SERVICE BULLETIN

00-8

Shimless Opening Cylinder with Long Axis Pivot

Available for variable size bag machine models 3, 5 and 7

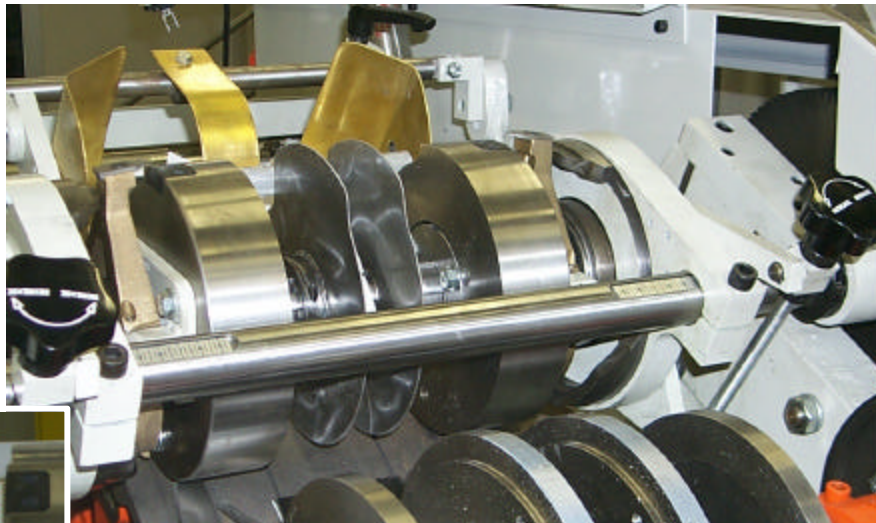
Improved bottom
formation

*Fingertips pull out
of bag straighter
for consistently
better bag bottom
formation*

- ◆ Two-piece fast-action cam provides quick, consistent fingertip grip and release
- ◆ Minimizes chance of corner tear-outs
- ◆ Reduced changeover time
 - One bolt loosens cylinder for lateral adjustment
 - Graduated scale set points
 - No cams to change, no setup gauge required
- ◆ Rugged design
 - Hardened cam follower
 - Heavy-duty compression spring
 - Heavy-duty finger body
